# REGIONAL REVIEW NOTIFICATION

ARC REVIEW CODE: R611031

**Name of Proposal:** Palisades Development

**Review Type:** Development of Regional Impact

TITLE: **GRTA DRI SITE PLAN**

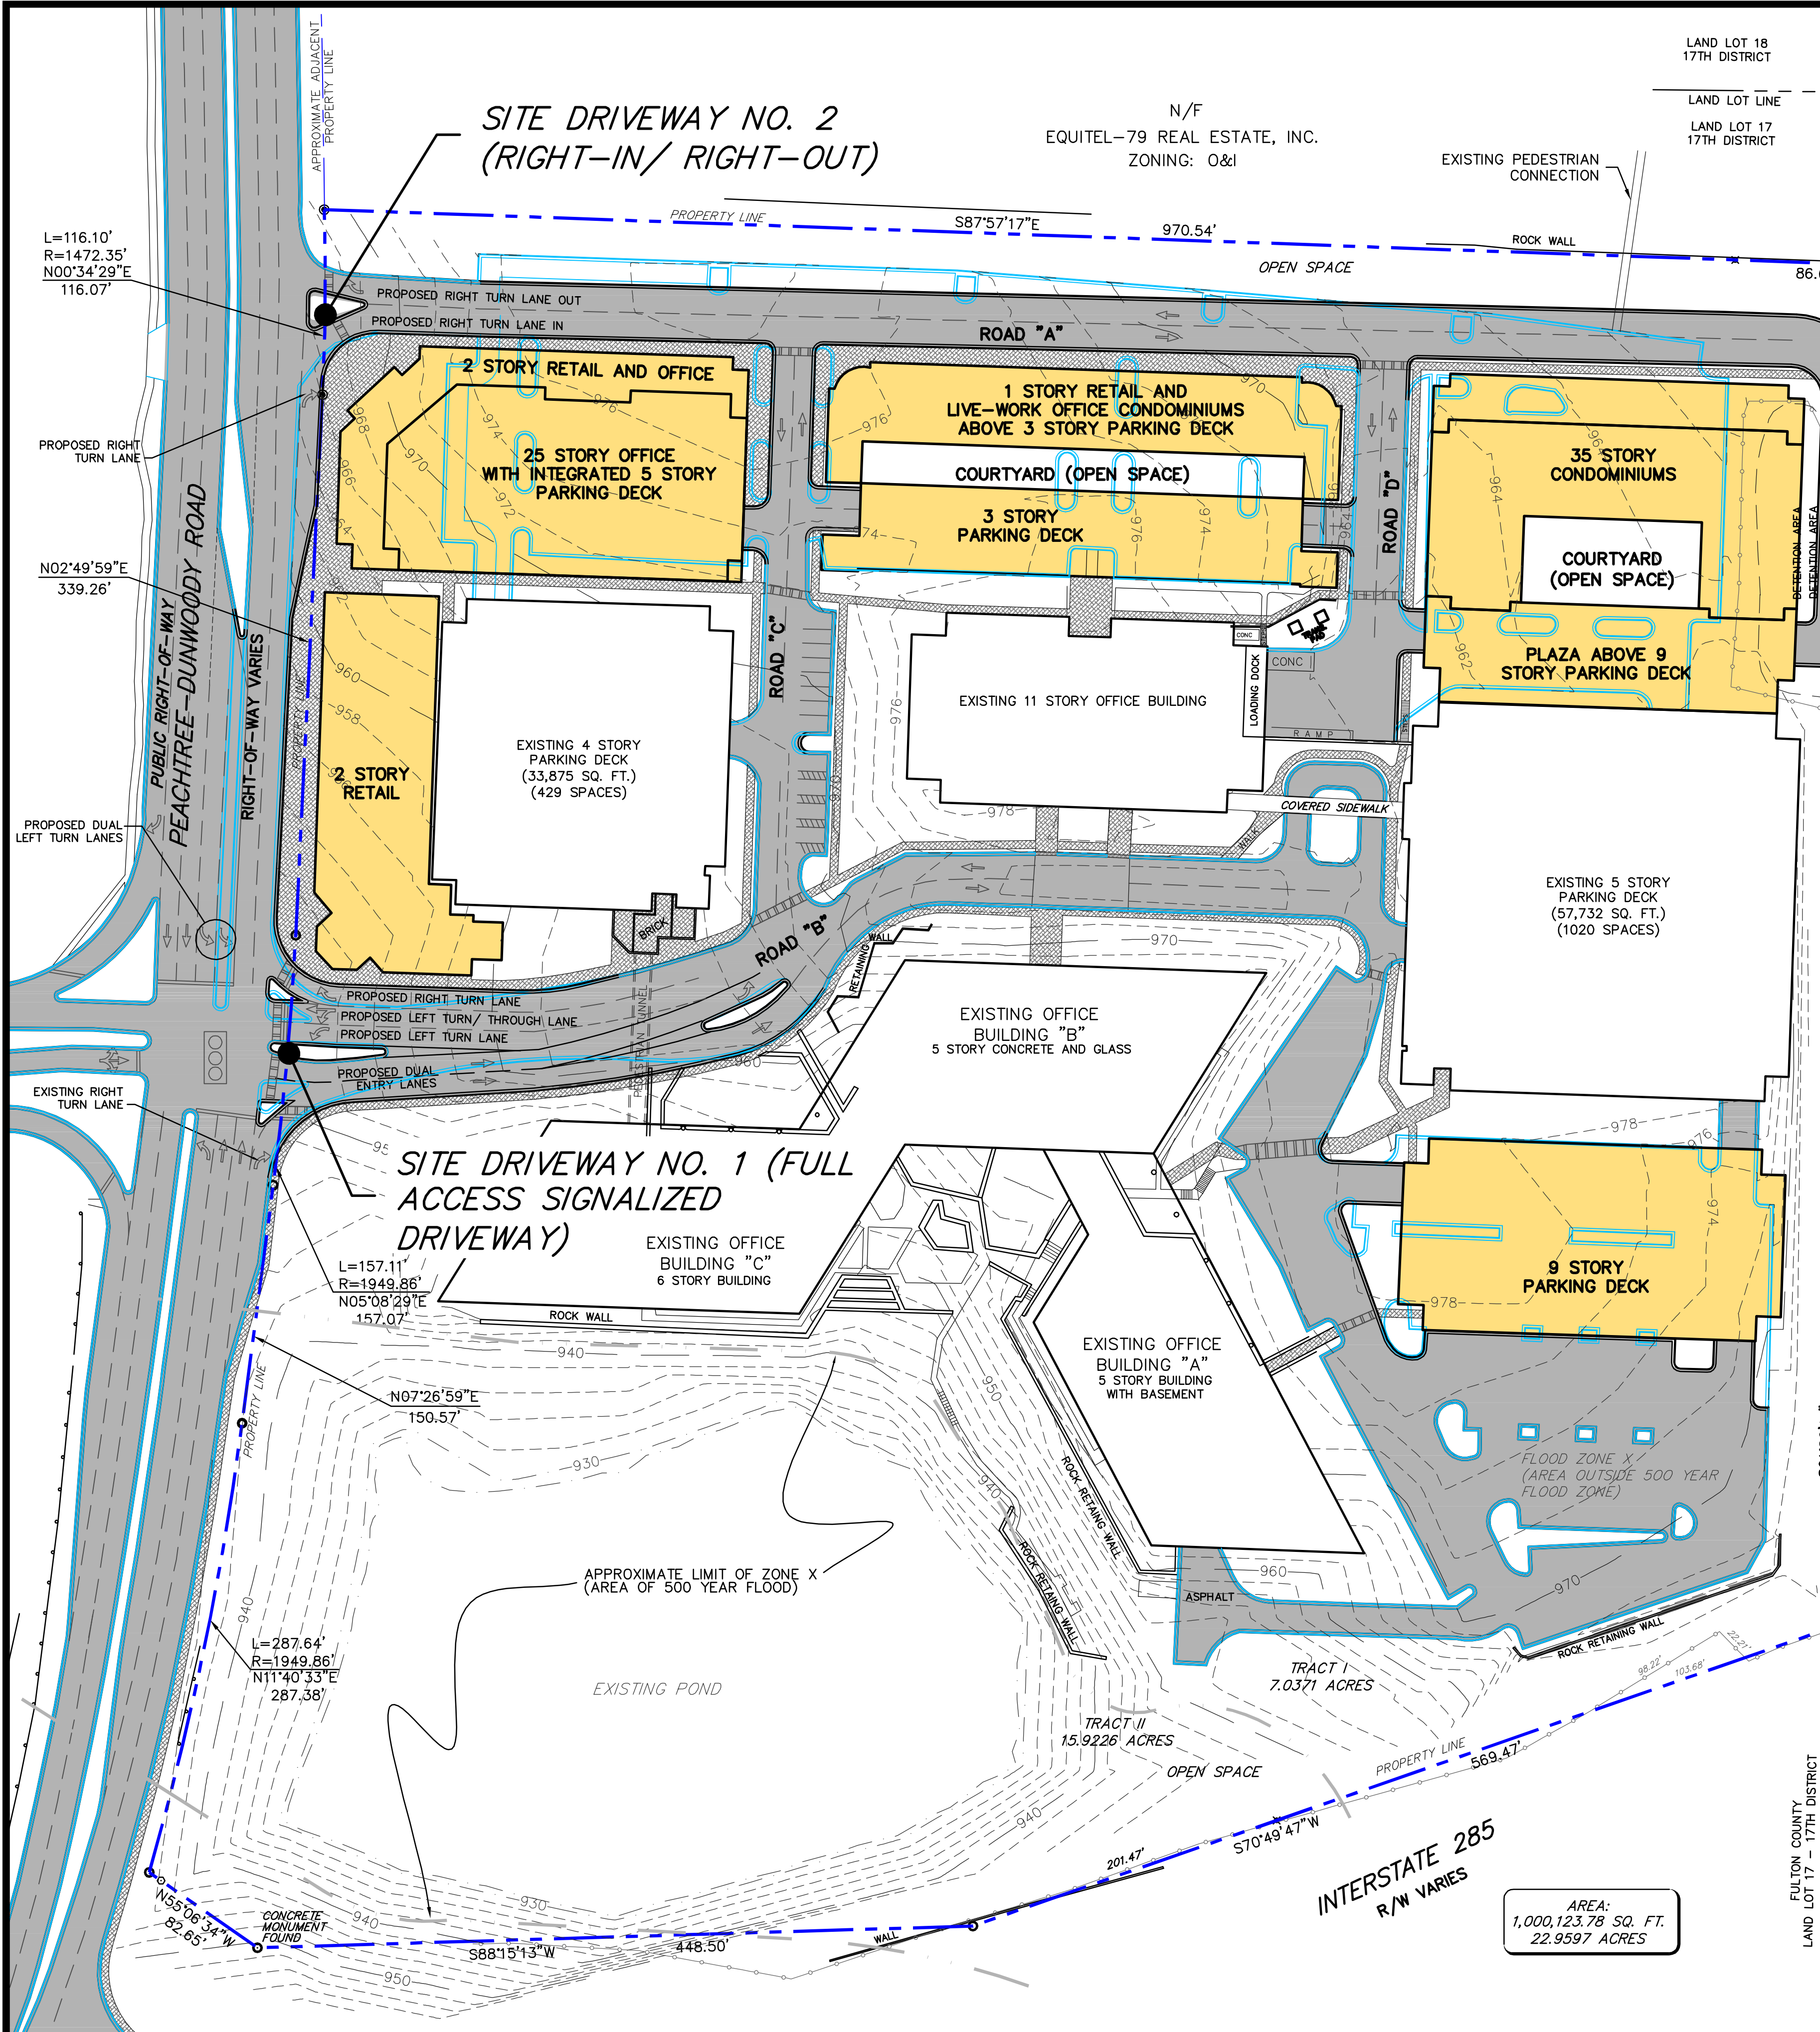
According to the traffic study, the Dunwoody MARTA Rail Station is located within a 1,900 ft walking distance from the site. The site plan shows the nearest pedestrian exit from the site to be located at Driveway 2, approximately 2,983 ft from the Dunwoody MARTA Rail Station. This would require pedestrians located on the eastern side of the development to walk approximately 3,967 ft or  $\frac{3}{4}$  of a mile to reach the Dunwoody MARTA Rail Station. It is strongly suggested that a pedestrian connection be made from the north east corner of the proposed project into the parcel immediately north of the site. This pedestrian connection would significantly reduce walking distance to the Dunwoody MARTA Rail Station and increase alternative mode trips to and from the site. Additionally, it is suggested that directional signage be provided to encourage the use of the Dunwoody MARTA Rail Station.

According to the traffic study, the Dunwoody MARTA Rail Station is located within a 1,900 ft walking distance from the site. The site plan shows the nearest pedestrian exit from the site to be located at Driveway 2, approximately 2,983 ft from the Dunwoody MARTA Rail Station. This would require pedestrians located on the eastern side of the development to walk approximately 3,967 ft or  $\frac{3}{4}$  of a mile to reach the Dunwoody MARTA Rail Station. It is strongly suggested that a pedestrian connection be made from the north east corner of the proposed project into the parcel immediately north of the site. This pedestrian connection would significantly reduce walking distance to the Dunwoody MARTA Rail Station and increase alternative mode trips to and from the site. Additionally, it is suggested that directional signage be provided to encourage the use of the Dunwoody MARTA Rail Station.
